Re: Tuscan Storm Drain Modifications

To: Mr. Brad Bingam
From: Bo K. Johnson
Subject: Tuscany Unit 2—Storm drain repair

IMPROVEMENT PLANS FOR

STORM DRAIN

No Scale
St. 2

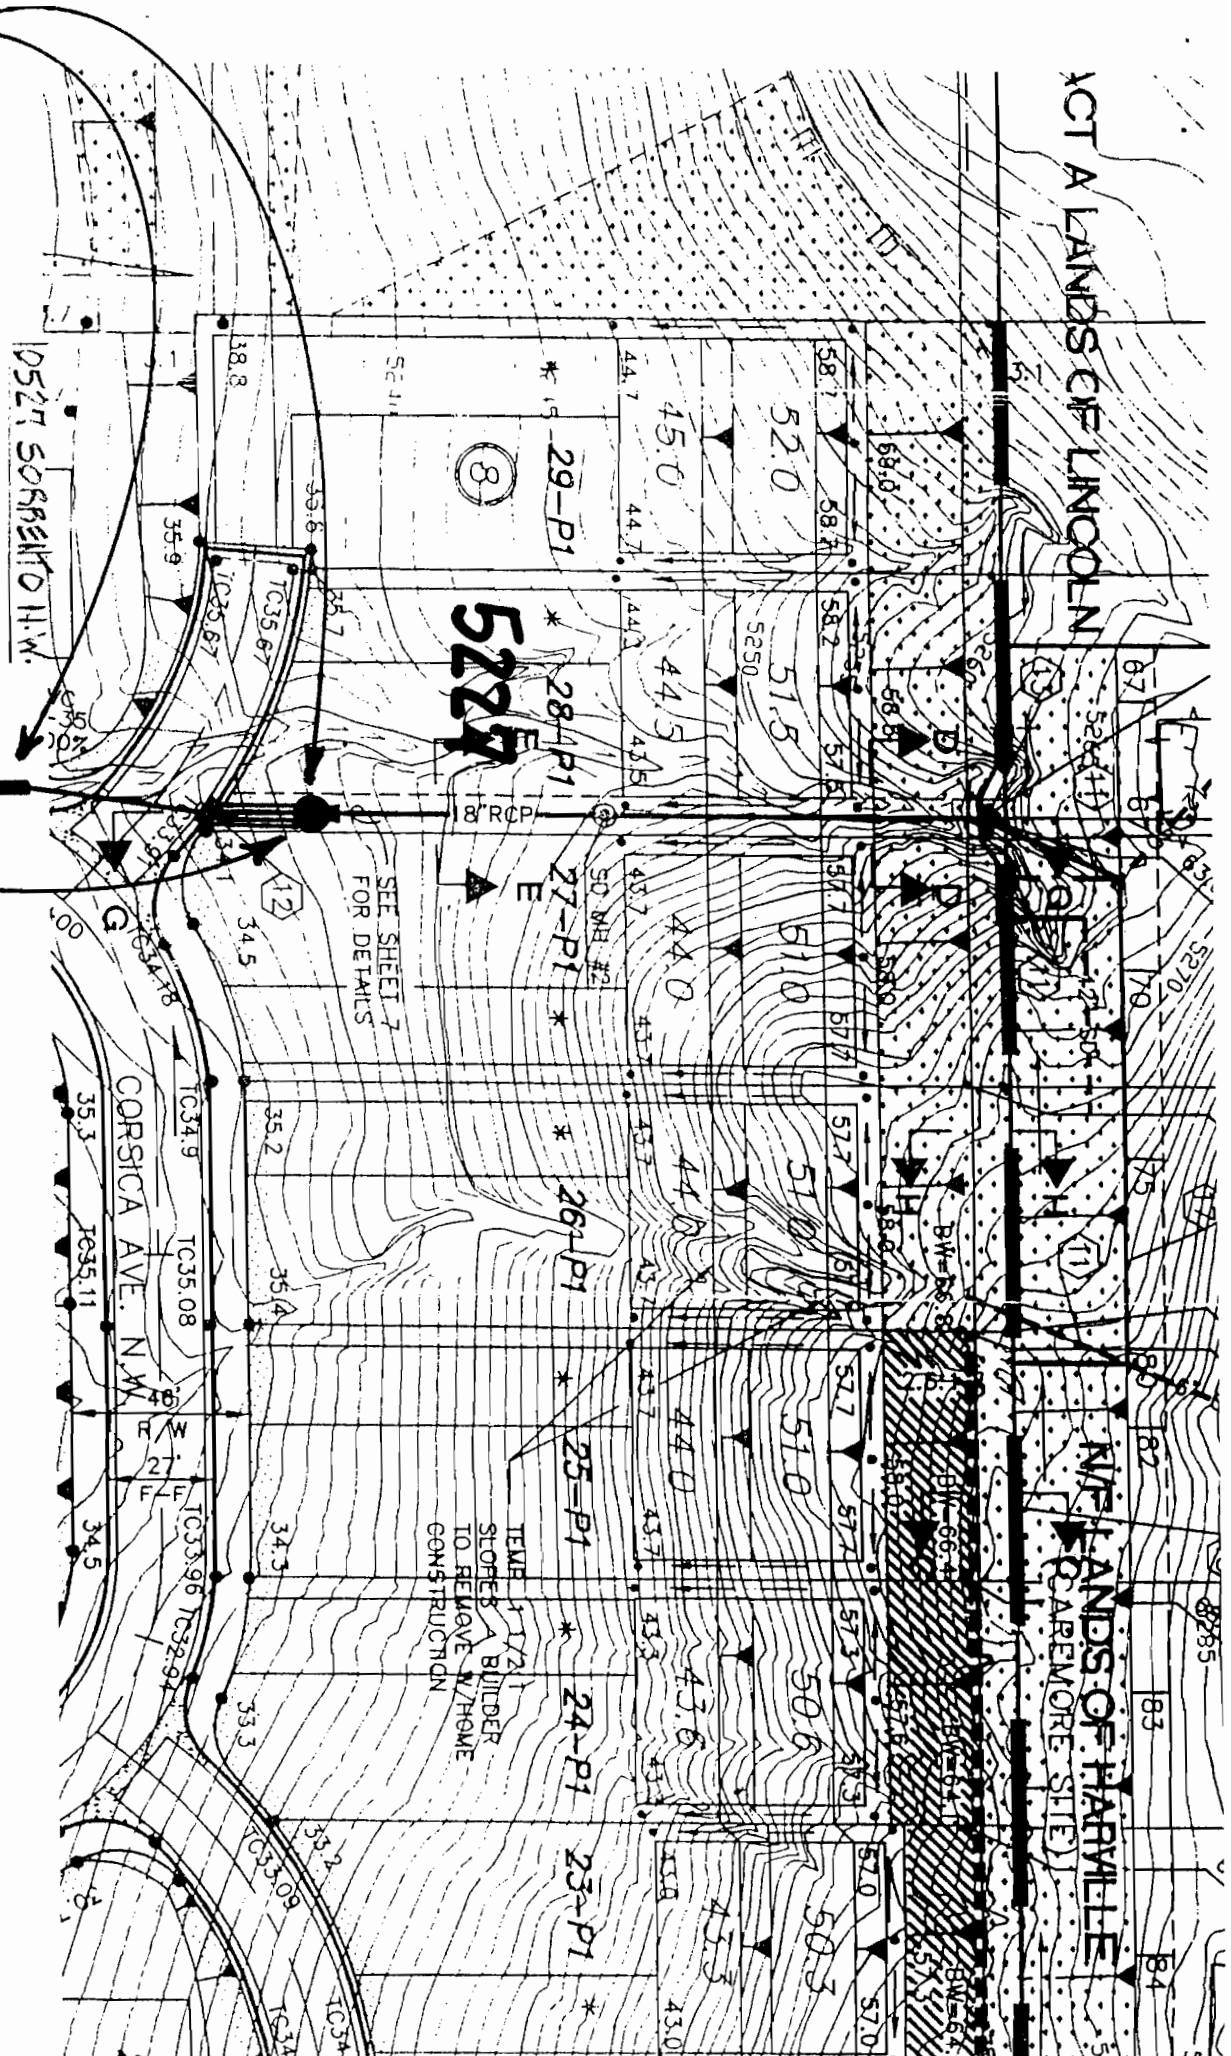
INSTALL NEW M.H. 25' NORTH OF R/W
OF CORSELY N.W.-LAWSON & S.D.
FILL EXISTING "BUBBLER BOX" @
DE27 SOURCE TO DR. NW.

INSTALL NEW 4 DIA. STORM DRAIN WITH HOLE -
TERMINATE EXISTING 8" PIPE IN NORTH SIDE OF
NEW MANHOLE - INSTALL 4-8 DIA. PVC PIPES FROM
NEW MANHOLE TO CURB FACE. REMOVE OR
ABANDON & SOLID FILL 8" R.C.P. CATCH BASIN & R.C.
TO "B" BOX.

NO SCALE
SH. 4

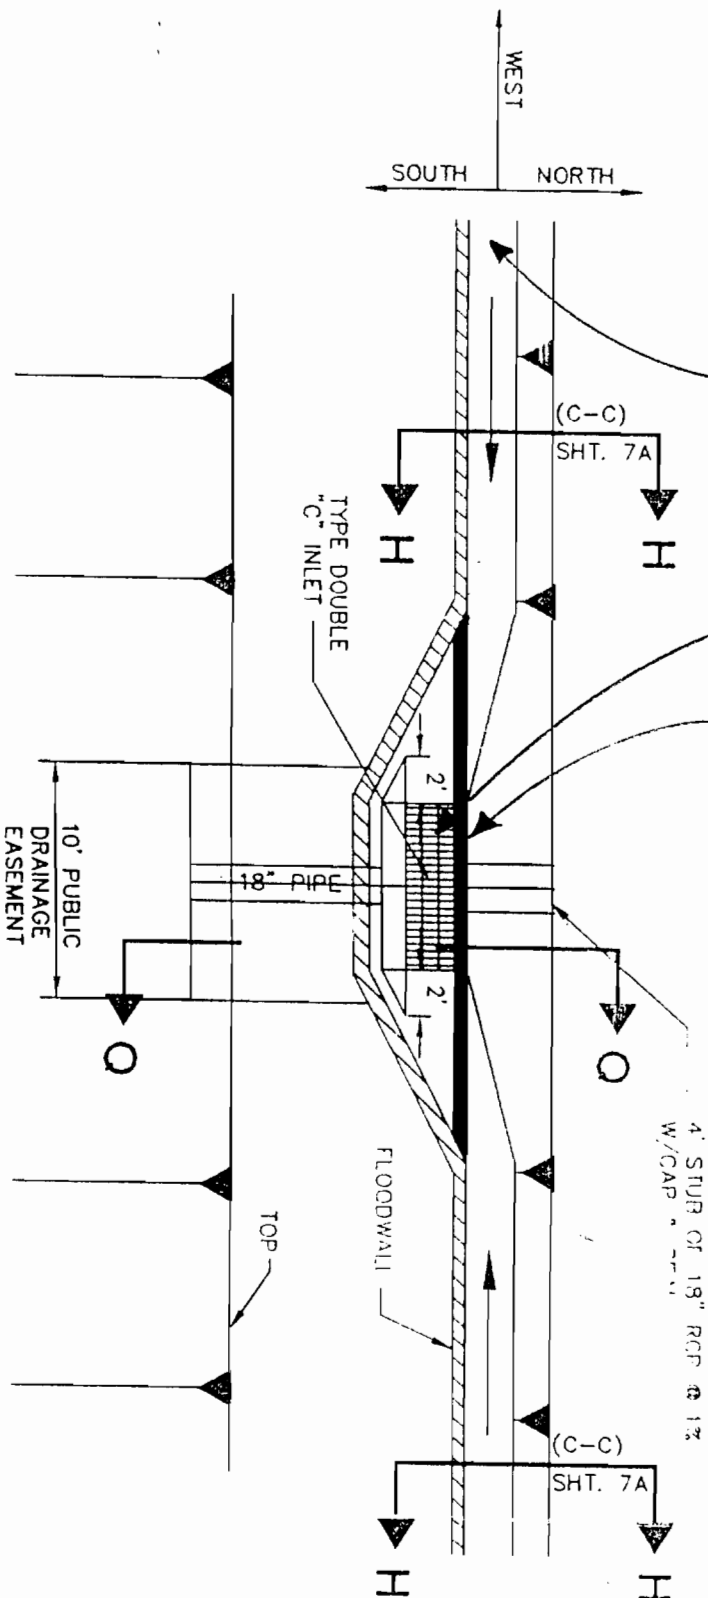
Brad—attached please find the corrected drawings for the repair—we changed the pipe to C-900 water pipe.

INSTALL 4-8" P.V.C. ~~SH. 40~~ C900
PIPES FROM I.H. TO CURB FACE

SWALE TRANSITION DETAIL/INLET
SCALE: 1"=8'

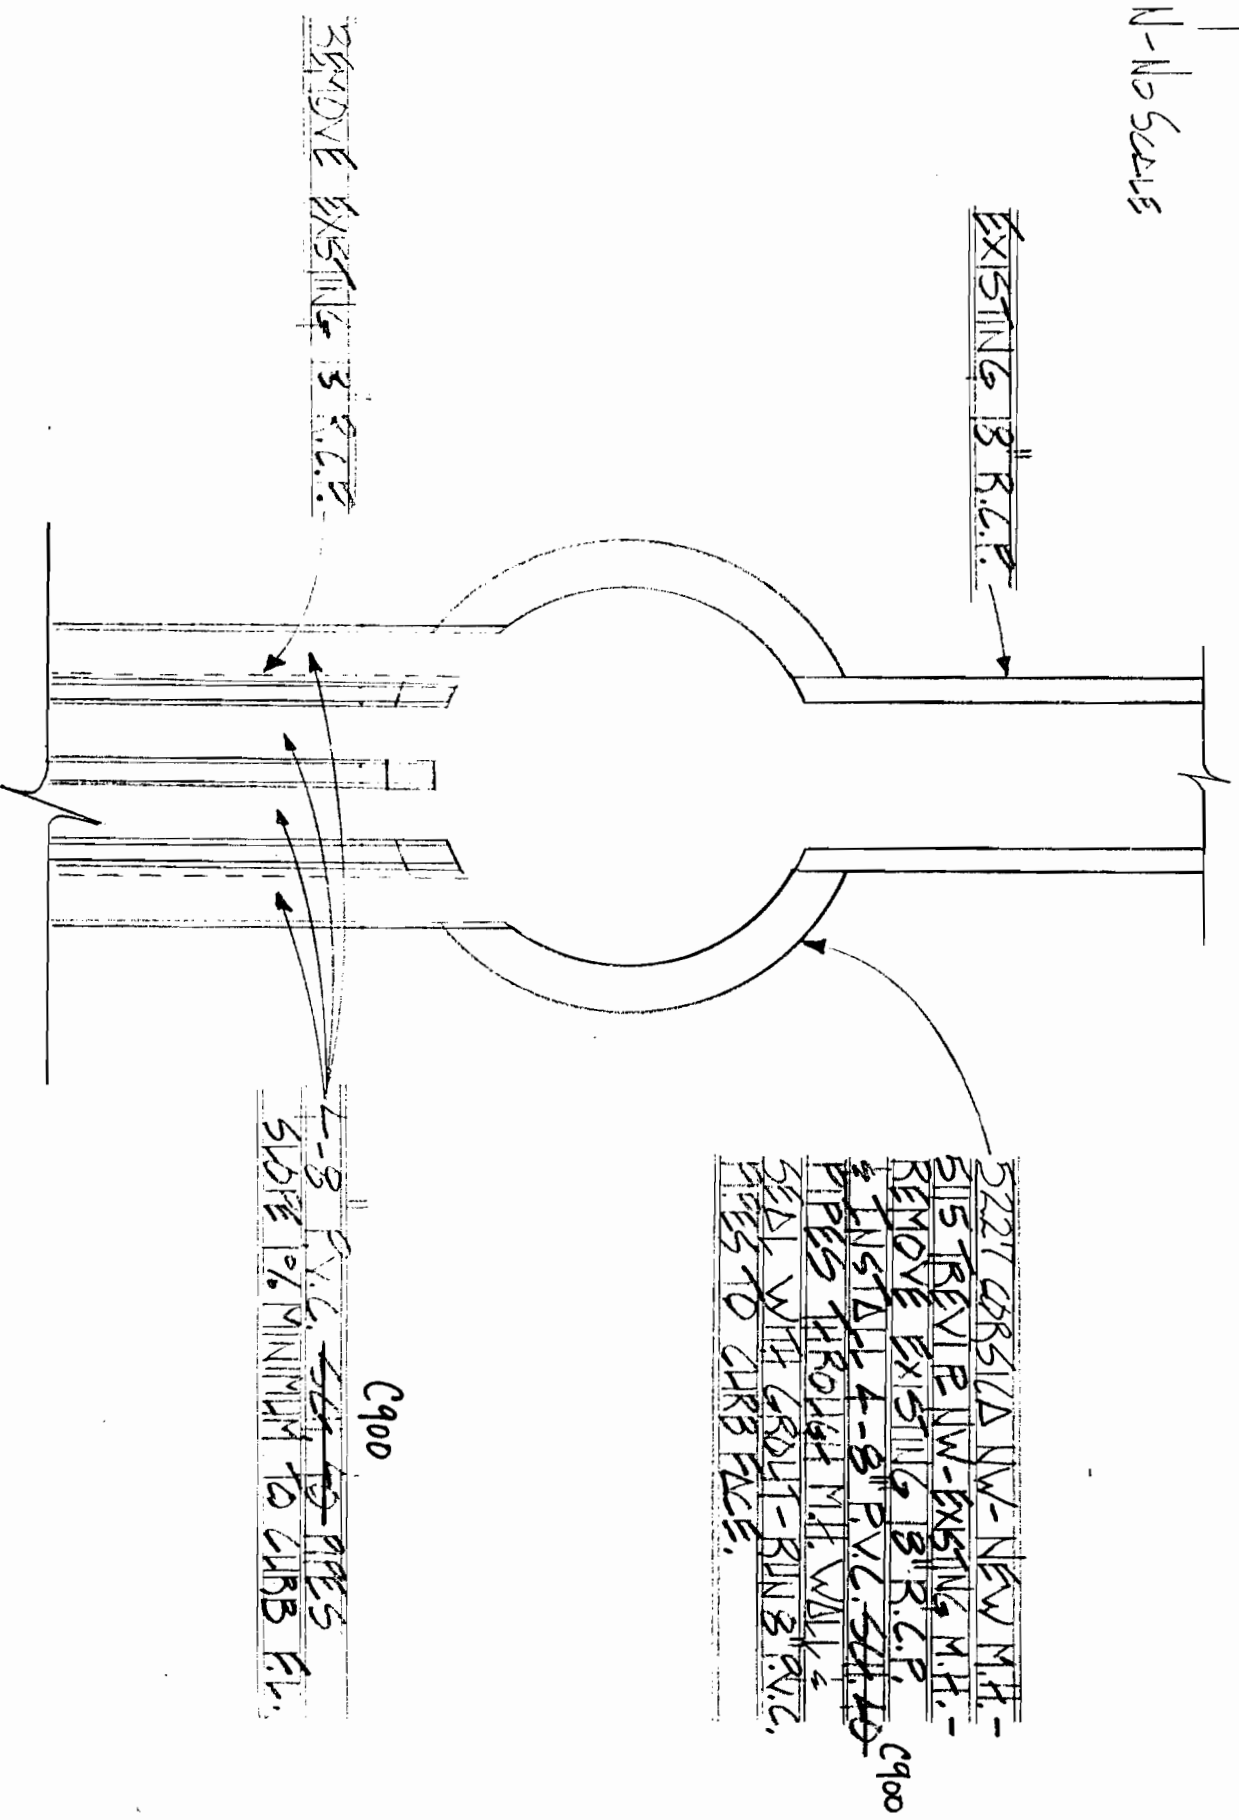
REMOVE SAND & DEBRIS
FROM ENTIRE LENGTH OF
FLOODWALL.

REMOVE DEBRIS FROM 2 EXISTING CATCH BASINS-
BUILD 16" HIGH BLOCK DIVERSION WALL AS SHOWN
TO MINIMIZE SEDIMENT BUILDUP IN CATCH BASINS.
